Update on 100GBASE-FR1 and 100GBASE-LR1 Wavelength Range Relaxation

Initial comments from September 15 interim meeting

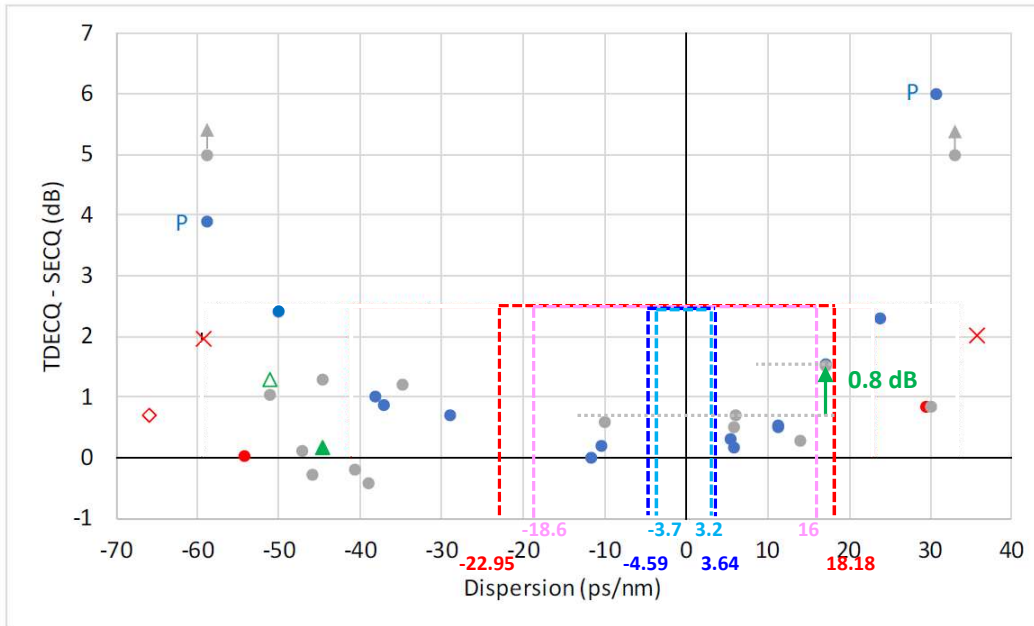
- ❑ Can the same TDECQ and Tx OMA be used with the extended wavelength range? Review the impact on optical link budget for the propose wavelength range again considering dispersion penalty and the differential group delay (DGD)-induced penalty.

In this proposal, the specifications of TDECQ and $|TDECQ-TECQ|$ are not changed to ensure the link budgets and interoperability with previously deployed spec, e.g. 100GBASE-DR and 400GBASE-DR4. This proposed broader wavelength range may impact dispersion penalty depends on the specific implementation, yet the studies below covering various implementations show it is still quite feasible to achieve the original specification of $|TDECQ-TECQ| \leq 2.5$ dB with margin.

Fig. 1

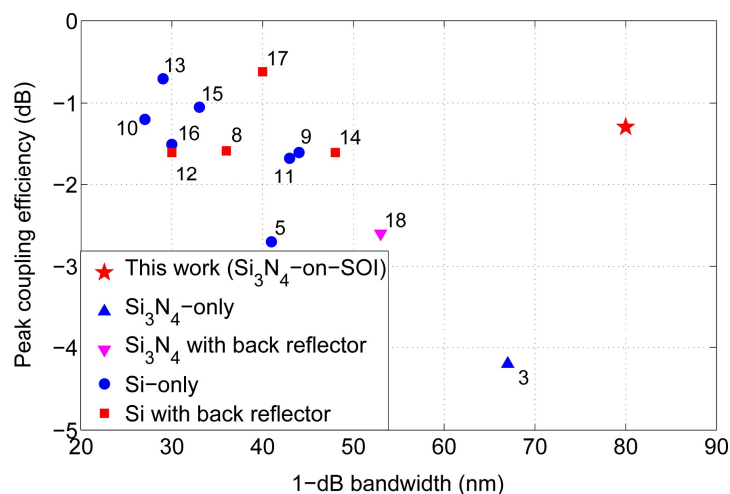
- ❑ It was also commented that the photodetector is not the only component in the optical receiver. Some implementations such as grating coupler may have larger wavelength-dependence in the receiver, so the broader wavelength range may lead to excess insertion loss and potential interoperability issue with the deployed units designed for the narrower wavelength range.

For the concern on receiver using grating coupler in some Si photonics implementations, we did a survey to understand the BW of various such implementation and found all of them have 1dB bandwidth larger than 20nm as illustrated in the chart below, so the excess insertion loss comparing the responsivity for 20nm range to 13nm range should be less than 0.5dB.

Considering the interoperability between 100GBASE-FR1/LR1 Tx and the deployed 100GBASE-DR/400GBASE-DR4 Rx for DR compliant link distances, as the Tx power for FR1 and LR1 is 0.7dB and 1.9dB higher than DR respectively, it is sufficient to compensate for the excess loss in the Rx due to the wavelength range relaxation.
